Well Name: ABSOLUT	Well Location: T23N / R6W / SEC 23 / NENW / 36.216072 / -107.440578	County or Parish/State: SANDOVAL / NM
Well Number: 1	Type of Well: OIL WELL	Allottee or Tribe Name:
Lease Number: NMNM17009	Unit or CA Name:	Unit or CA Number:
US Well Number: 300432086400S1	Operator: DUGAN PRODUCTION CORPORATION

Notice of Intent

Notice of Intent – Plug and Abandonment

Operator: Dugan Production Corporation
Lease: NMNM 017009
Well(s): Absolut 1, US Well # 30-043-20864
Sundry Notice ID #: 2893059

Absolut 1

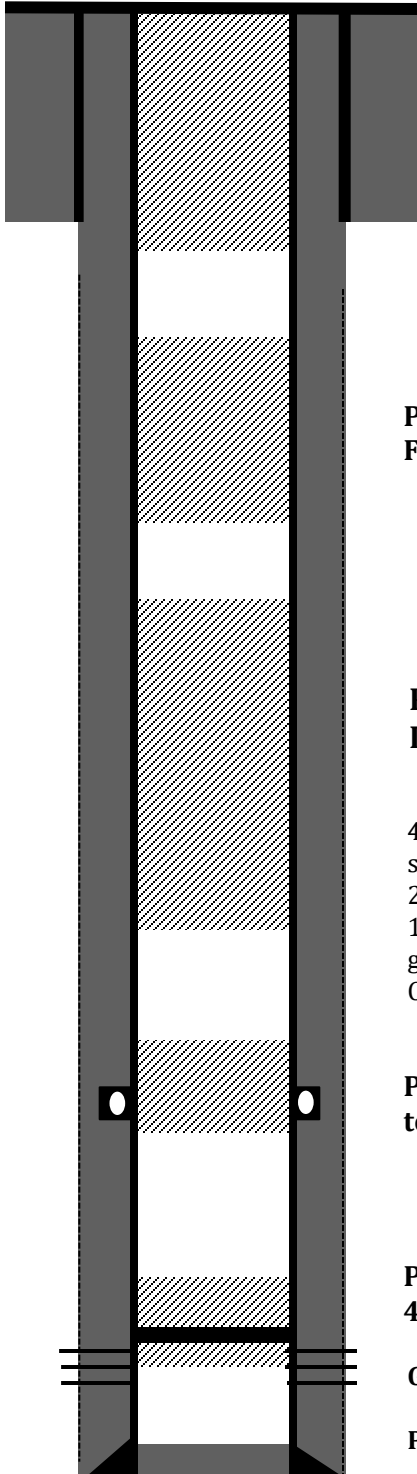
1. Plugging operations authorized are subject to the attached "General Requirements for Permanent Abandonment of Wells on Federal and Indian Lease."
2. The following modifications to your plugging program are to be made:
 - a. Modify Plug 4 bottom of cement to 2060' to cover BLM geologist picked for Pictured Cliffs top at 2010'.
3. **Notification:** Farmington Office is to be notified at least 24 hours before the plugging operations commence at (505) 564 7750.

Remarks: Plug IV needs to cover BLM-picked Pictured Cliffs top, approximately 10' lower than proposed.
